TOWN OF WINTER PARK PLANNING COMMISSION Tuesday, September 9, 2025 8:00 AM

Minor Site Plan - 487 Leland Creek Way - Lot 26, Leland Creek Subdivision -RE

Wymore/Lowery Residence (PLN25-077)

RE Minor Site Plan - 70 Cub Creek Way- Lot 4, Lakota Point Filing No. 1 - Single

A1

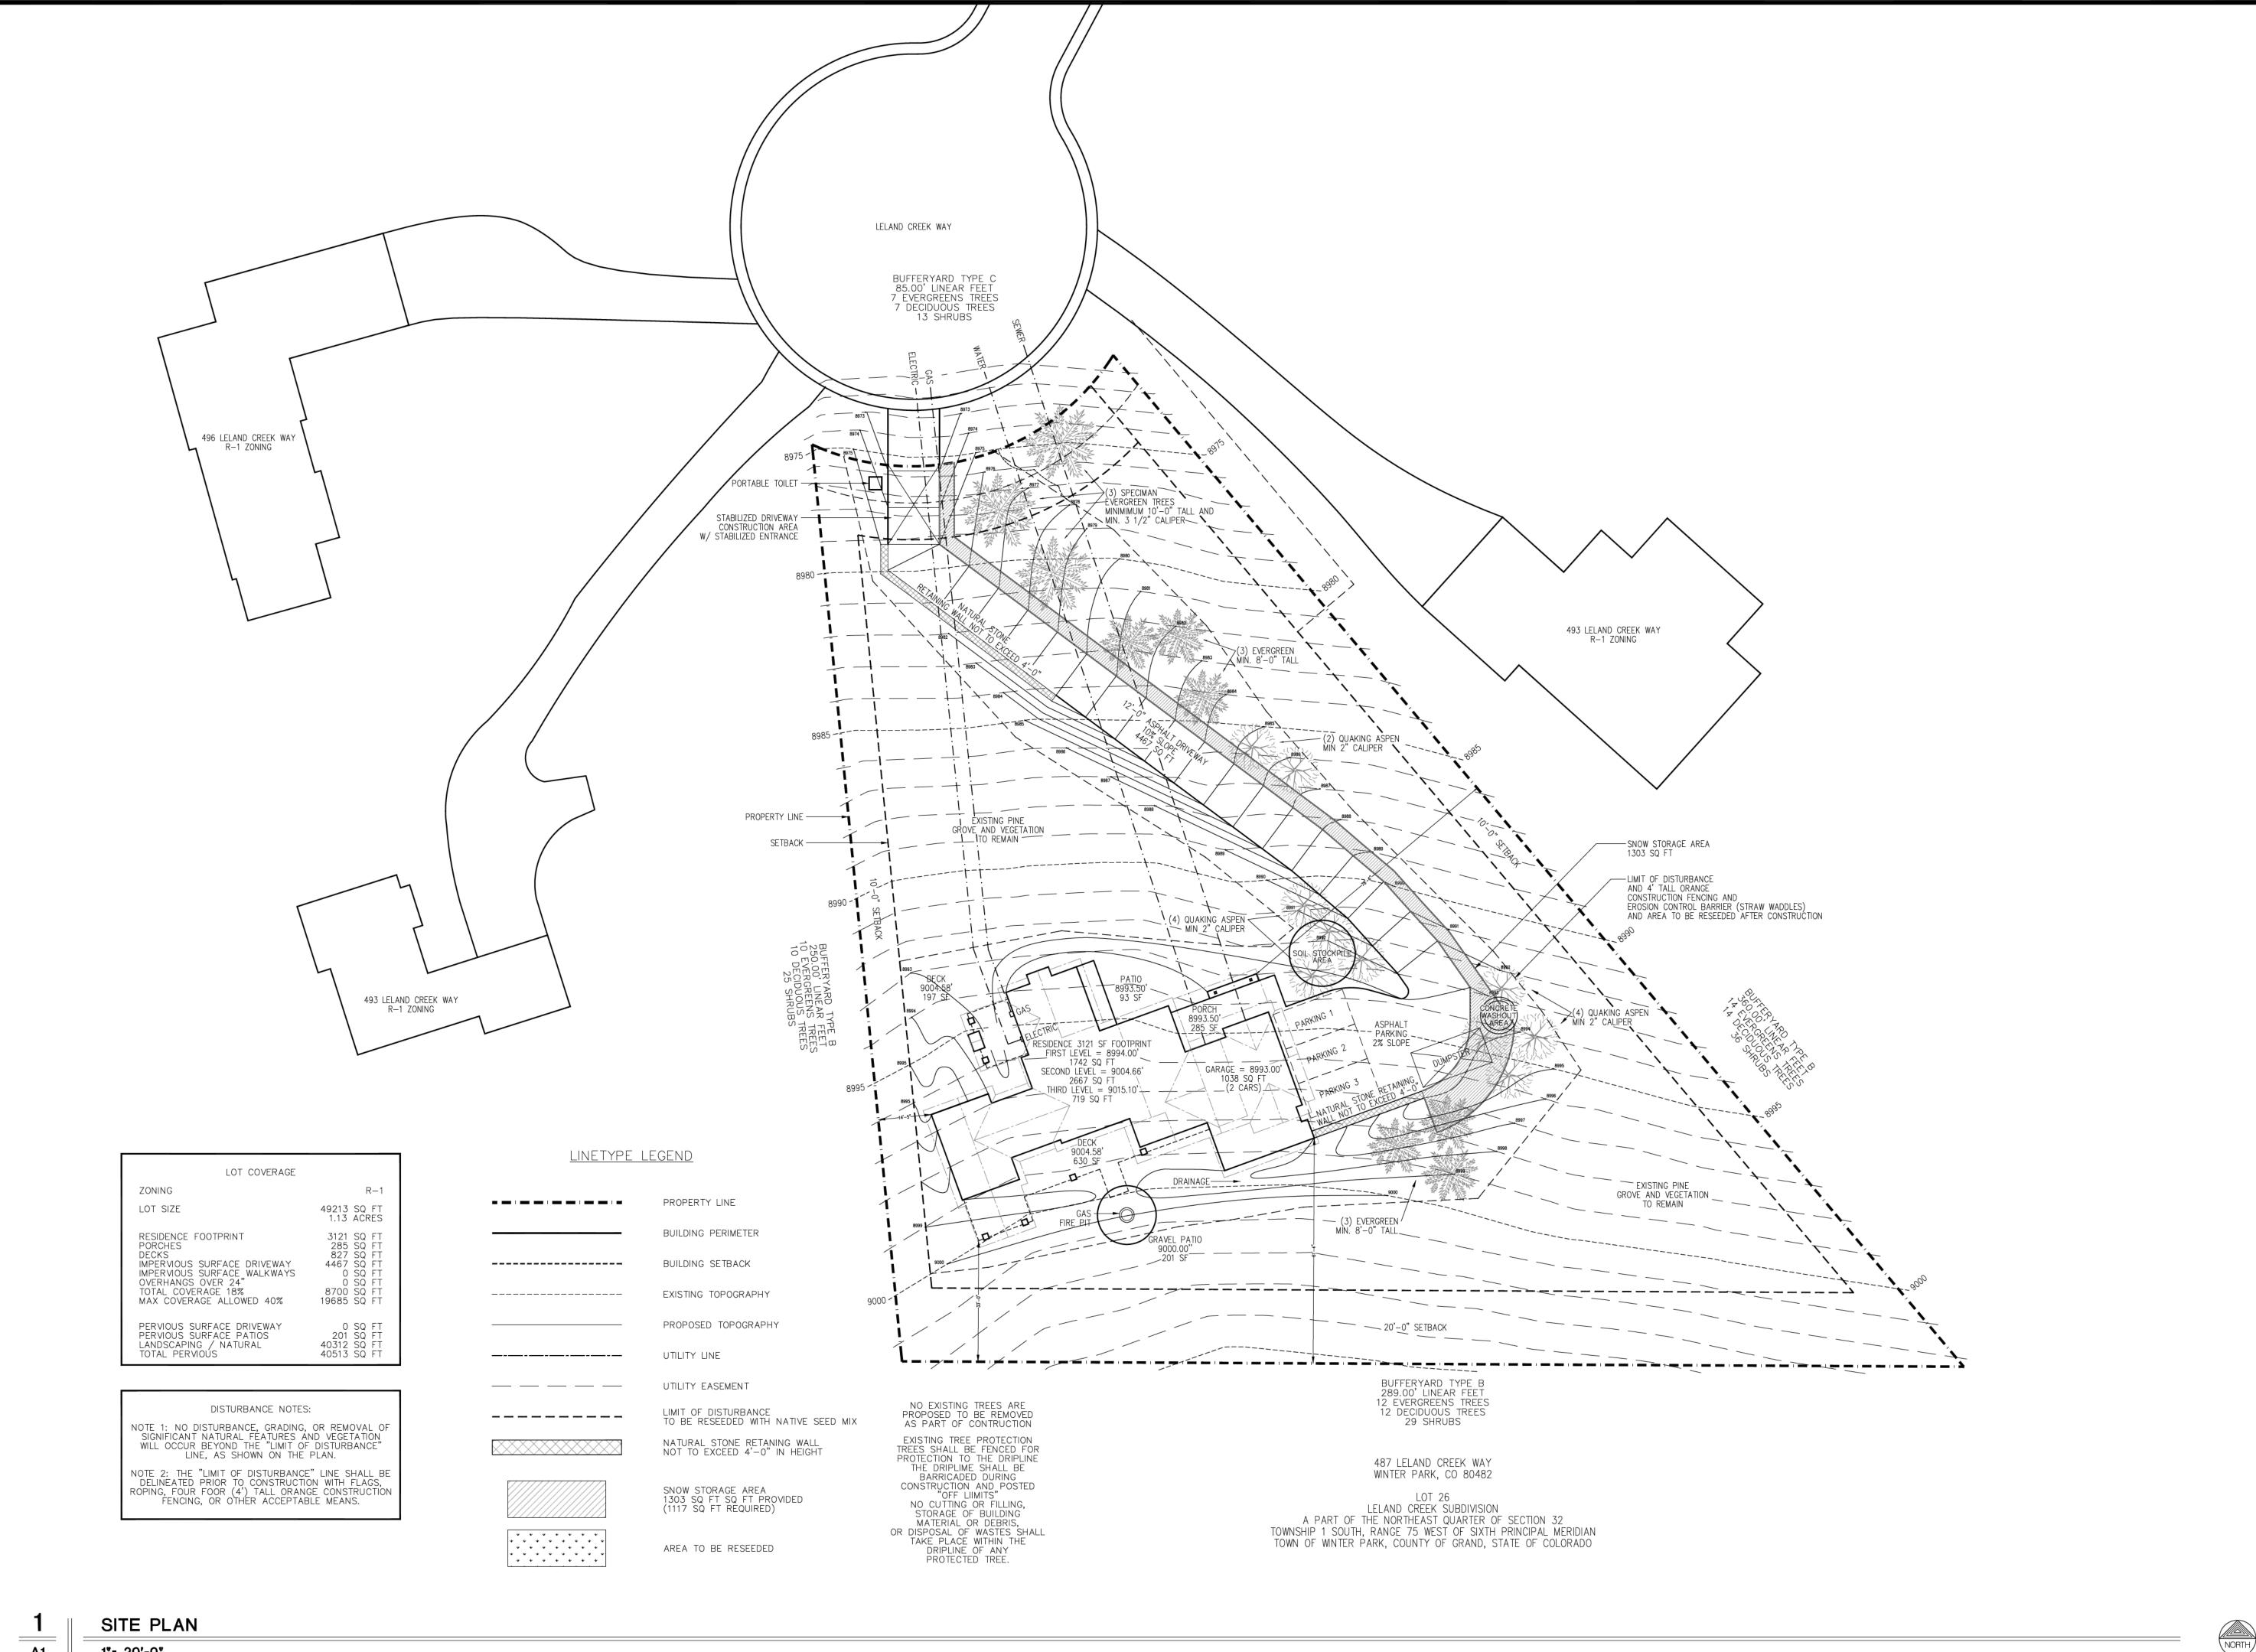
- ➤ **At building permit,** confirm submitted plans comply with the Leland Creek Subdivision Design Guidelines as noted below:
 - o The triangular windows will not be considered please revise

- Exterior wall vertical and horizontal siding. Unbroken wall plans will not be allowed to have a vertical material transition. See crude redline, we suggest board and bat siding where vertical redlines are drawn so material on a wall plane is consistent.

Sheet Number A2.0

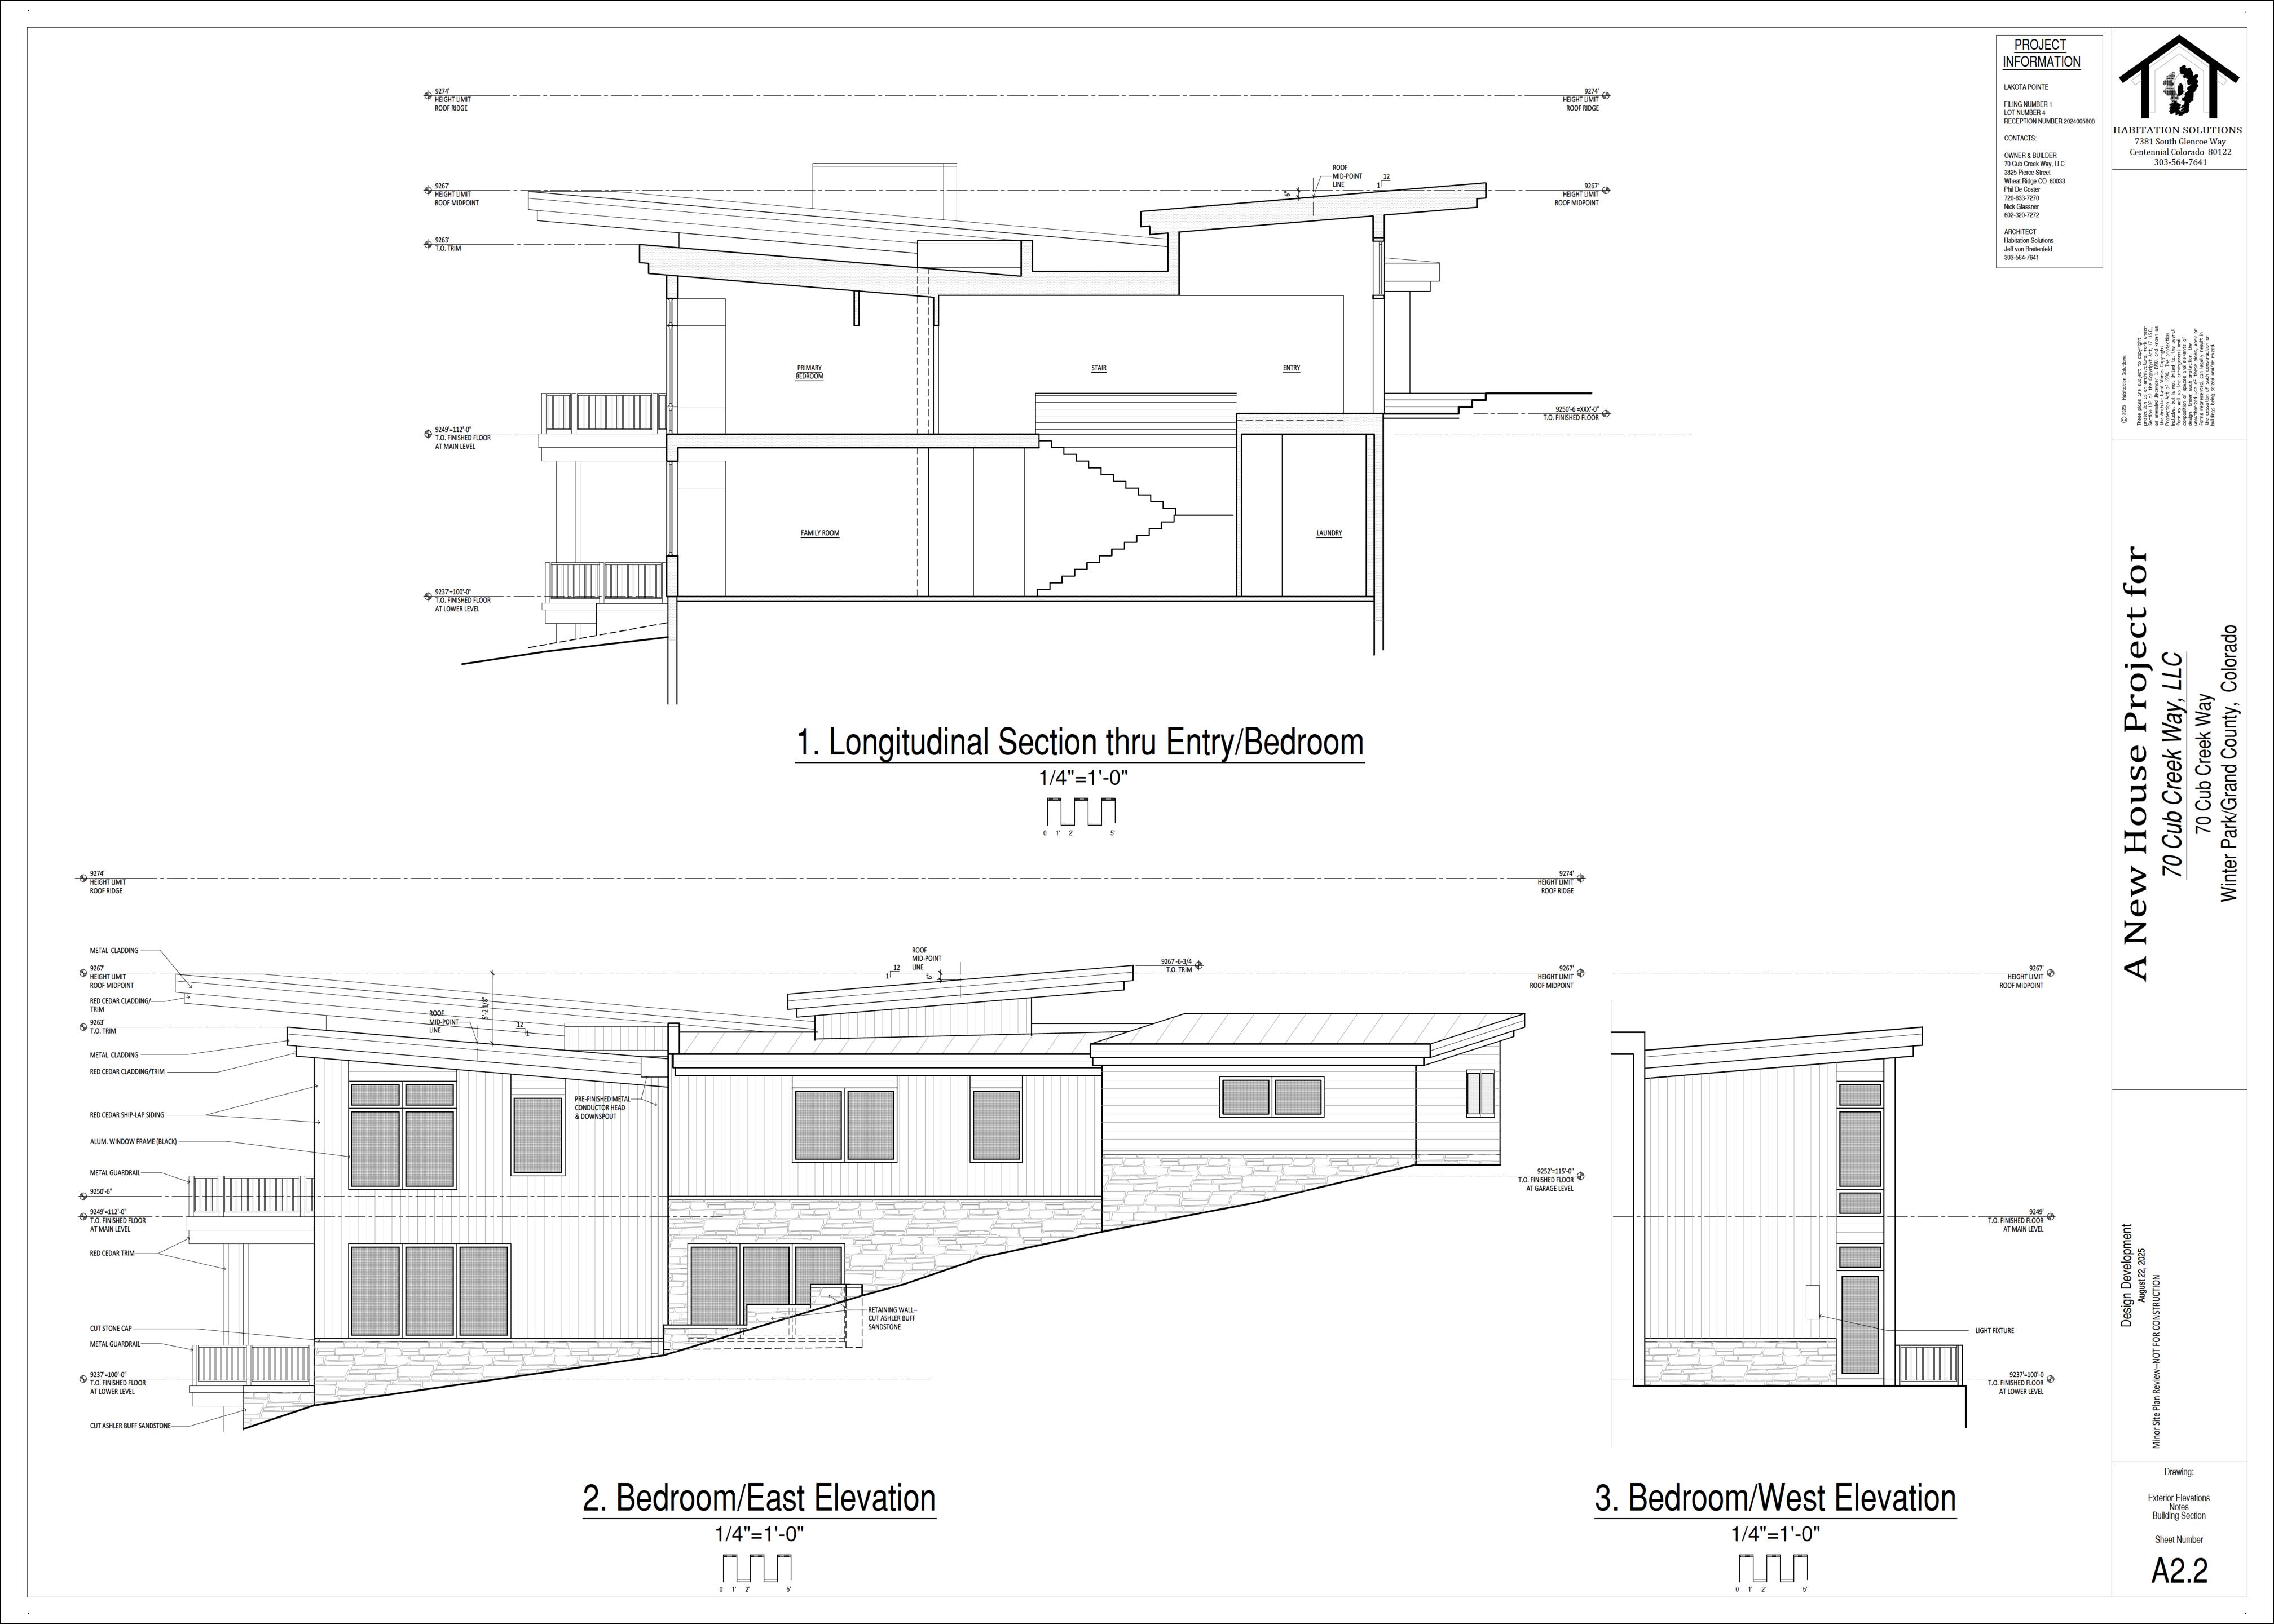
Partially Satisfactory. The applicant proposes 7 Nate Outdoor Wall Sconces at 62 lumens each, 9 Luminess Step Lights at 30 lumens each, and 7 Luna LED Outdoor Ceiling Lights at 600 lumens each, for a total of 4,904 lumens. This total complies with the maximum 5,100-lumen allowance for single-family residences. Photometric plans are not required for single-family homes. All fixtures are rated at or below 3,000K Correlated Color Temperature (CCT). It should be noted that the applicant's original submittal exceeded the lumen allowance; however, a revised lighting plan has been provided that is now compliant with the applicable standards. The elevation plans will need to be updated, if applicable, to reflect this revised lighting plan.

At the time of building permit submittal, the applicant shall revise the elevation drawings to match the outdoor lighting tabulation and cut sheets, ensuring the plans fully demonstrate compliance with UDC requirements.

DRIVEWAY VERTICAL PROFILE

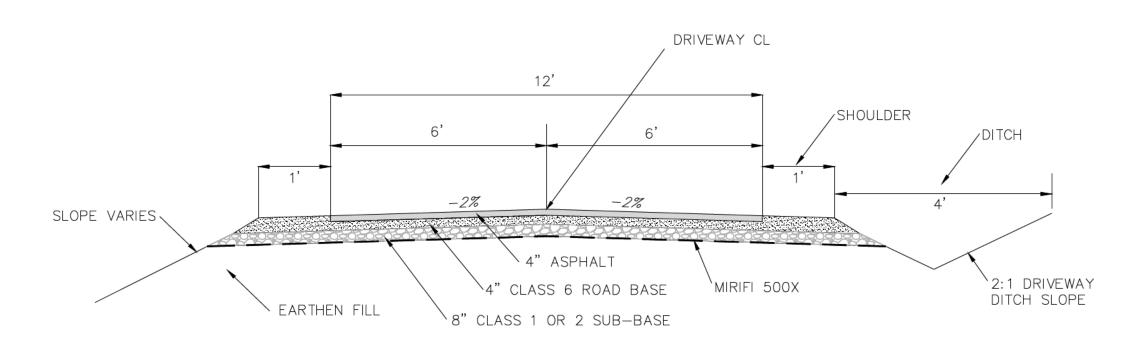
Partially Satisfactory. The proposed driveway appears to meet the required standards for width and approach. However, due to site characteristics the driveway does not adhere to the following component of section 4.3.2 (Driveway Setback from Property Line) and 4.4 (Alignment) in the Town of Winter Park Standards and Specifications for Design and Construction (SSDC).

"4.3.2 Driveway Setback from Property Line

All edges of driveways shall be a minimum of seven feet (7') from the adjacent property line....."

"4.4 Alignment

Unless otherwise required by the Town Subdivision Process, the first twenty-four feet (24') shall not exceed 5% and after the first twenty-four feet (24') the following is required for all driveways"

> At the time of building permit submittal, the driveway shall either comply with the standards outlined in the SSDC or be reviewed and approved through the applicable deviation procedures associated with these standards.
